SSD_7054: LEES 1 BUILDING AND SSD_7055: F23 ADMINISTRATION BUILDING
UNIVERSITY OF SYDNEY RESPONSE TO SUBMISSIONS

The University of Sydney has reviewed all submissions received during the statutory public exhibition period of State Significant Application *SSD 7054 – F07 LEES 1 Building* and the *SSD 7055 – F23 Administrative Building*, both located on the southern edge of the University's Camperdown campus fronting City Road.

Figure 2 Existing and Erroneous Layouts

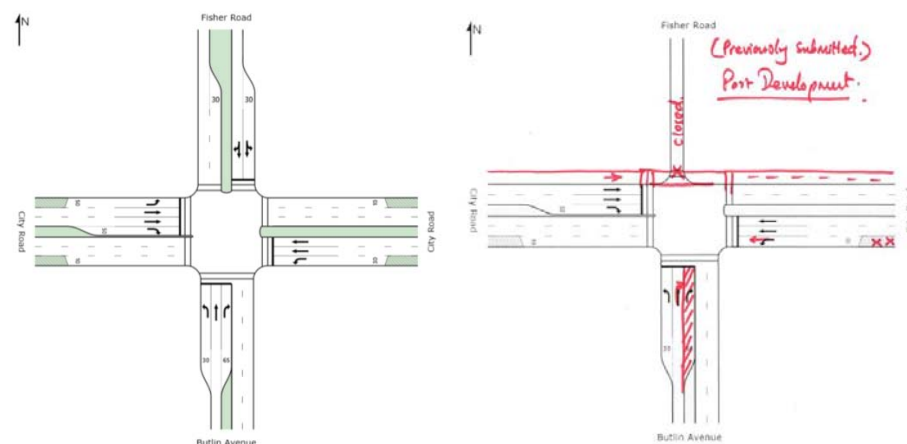
A detailed review of the previously submitted City Road/Butlin Avenue model revealed a geometrical error which resulted in the counter-intuitive output. Details are explained below.

The existing layout and previously submitted but erroneous layouts are shown on Figure 2 below.

Figure 3 Submitted post-development configuration

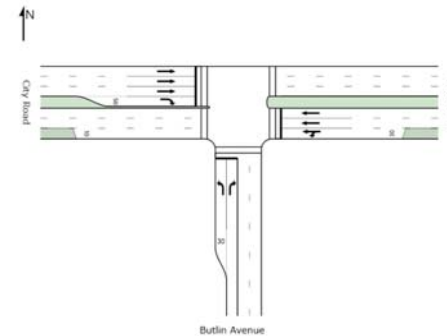
The rectified layout which reflects the most recently proposed design is reflected on Figure 3.

Based on the above, the Sidra model has been revised to using the following parameters:

- A three-legged intersection (i.e. T-Intersection)
- Deletion of a northbound right turn bay
- Appointment of practical cycle time because the intersection is now modified, and therefore readapted signal timings.

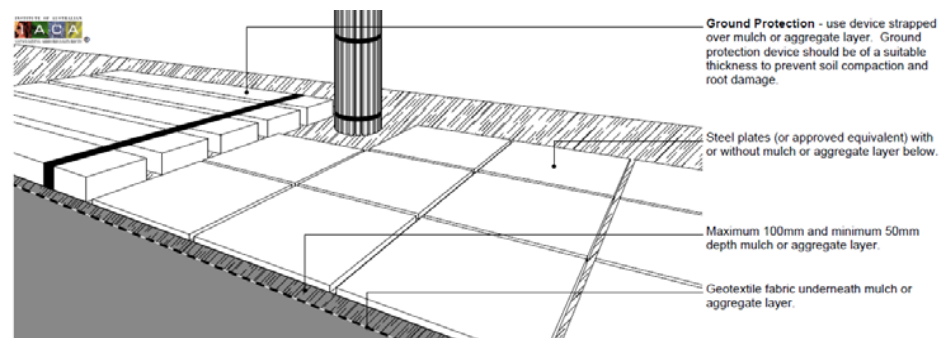
SSD 7054 – F07 LEES 1 BUILDING	
CoS ISSUE – LEES1	USYD RESPONSE
Following a recent site inspection, it is considered that major pruning of T971, T972 and T973 will be required to facilitate construction. It is expected that the current design and scaffolding will require the removal of large primary branches (200 – 400mm diameter). To minimise the impacts of the new building on the significant fig trees, it is recommended that the building is setback further from the trees to allow a minimum distance of 2 metres from the edge of the existing canopy. This allows for scaffolding to be located within a 1 metre zone from the final edge of the building façade. Further, once the construction is complete it allows the tree 1 metre for growth, and 1 metre for clearance of the building facade. An accurate survey of the tree height, spread and crown shape should be undertaken and overlayed onto the proposed plans to ensure the setback is sufficient from the existing significant trees.	Stage 1 root pruning works were carried out in August 2105 in accordance with City of Sydney Notice of Determination TPR/2015/28, 16 July 2015. A copy the Notice of Determination is attached under Appendix 1.01. Stage 2 root pruning and crown pruning works were carried out on 29 July 2016 in accordance with City of Sydney Notice of Determination TPR/2016/228 dated 15 June 2016. A copy the Notice of Determination is attached under Appendix 1.02. As per Section 3.6.7 of the Arboricultural Impact Assessment (Rev D, 11.04.16), any additional pruning in sections of the trees' upper crowns to accommodate sections of the proposed building projection will be limited to branches no greater than 50mm diameter. This pruning work should represent terminal growth only which could be either pruned with hand tools from hoardings/scaffolding or temporarily pushed back. The proposed scaffolding (encompassing both the formwork support system & edge protection) required to access the building edge during construction is temporary in nature and will be coordinated in conjunction with advice from the Arborist consultant. To protect the underlying soil from compaction temporary ground protection such as ground mats, steel road plates or approved equivalent will be installed.

Indicative ground protection within Tree Protection Zone detail follows:

1. Built Form & Scale - Building Alignment

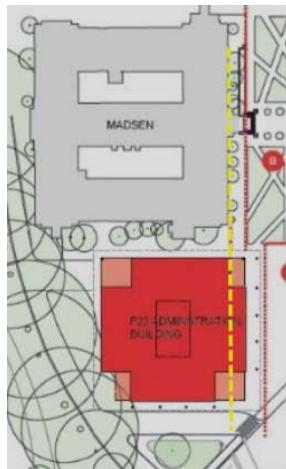
It is recommended the preferred eastern alignment for the F23 building respects the primary façade alignment of the Madsen Building.

The alignment of the Marsden and Anderson Stuart Buildings is more apparent in plan, than in reality. Wilkinson's vision of having a series of major university buildings fronting Victoria Park (SHI, Fig.2.3, p.8) was shattered by the post WWII construction of several new buildings. The building alignment on the western edge of Eastern Avenue was disrupted by the construction of the Chemistry Building (1958) and this was followed by the construction of several buildings on the city side of Eastern Avenue.

The slight protrusion of F23 beyond the Madsen Building, therefore, is of less importance than the urban design issue of establishing "a better sense of identity, arrival and transition as the eastern gateway to the main campus and provide a more complementary solution and scale to the open landscape of the junction between City Road and Eastern Avenue linking into the axial arrangement of Eastern Avenue" as raised by the HC, and previously flagged in the F23 SHI (p.28).

Figure 1 Car Share spaces near the campus

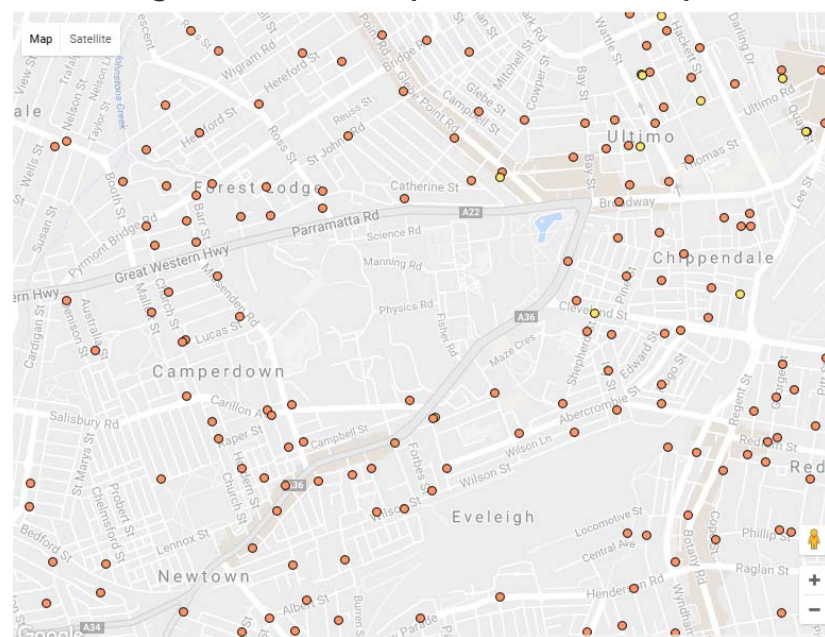
3. Car share spaces must be provided on site as per DCP12 Section 3.11.2.	The DCP car share requirement does not apply to tertiary education institution. However, the University notes that the areas surrounding the campus are well served by car share spaces (Figure 1 overleaf). While there is no statutory requirement for such provision within the campus, the University and traffic consultants GTA support the appointment of a car share bay in the campus to service local students/staff. However, placement of these spaces within basement carpark is not ideal due to issues relating to accessibility and security. Therefore, should they be provided then it is recommended that they are located at ground level

Figure 5 Recommended Set Down and Pick Up bay

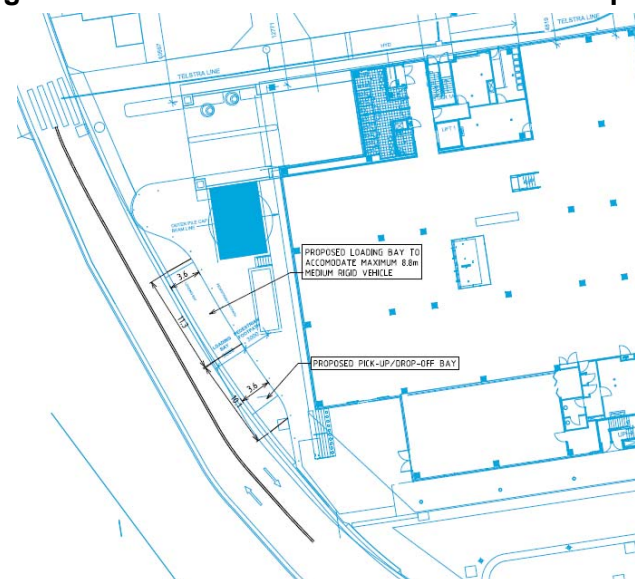
There is currently no dedicated set down and pick up area for taxis within the campus grounds. It was observed that taxis typically set down/pick up passengers within the available car parking spaces and do not appear to impede on the relatively lowly trafficked campus road network.

Notwithstanding, traffic consultants GTA conclude that a dedicated set down and pick up area would be a positive enhancement to the campus amenity and accessibility as a whole, and therefore recommend the appointment of one adjoining the F23 building (refer Figure 5 of the **Appendix 2.01** - Transport Consultant GTA Letter).

Figure 6 Indicative Signal Plan by RMS

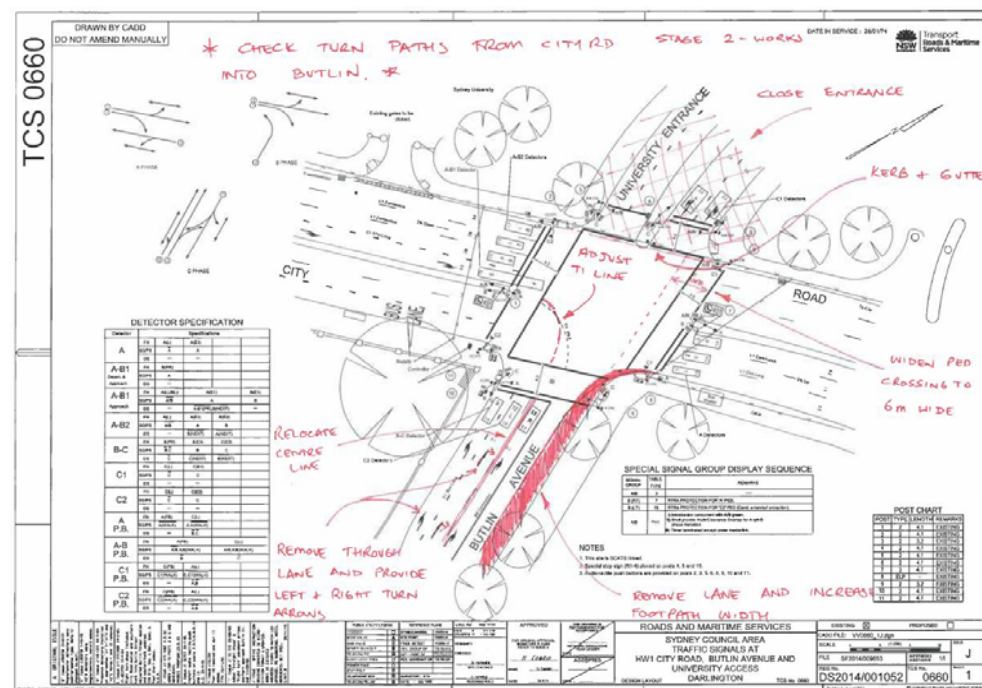
Noted: Traffic consultants GTA has previously consulted with the RMS and has been provided with a guiding signal plan to progress with the design. Details of the proposed Signal Plan issued by RMS are indicated in Figure 6 overleaf and found within the **Appendix 2.01** - Transport Consultant GTA Letter. This design will be developed and formalised by GTA and submitted to RMS with accompanying traffic signal control plan modifications for their review and formal approval.
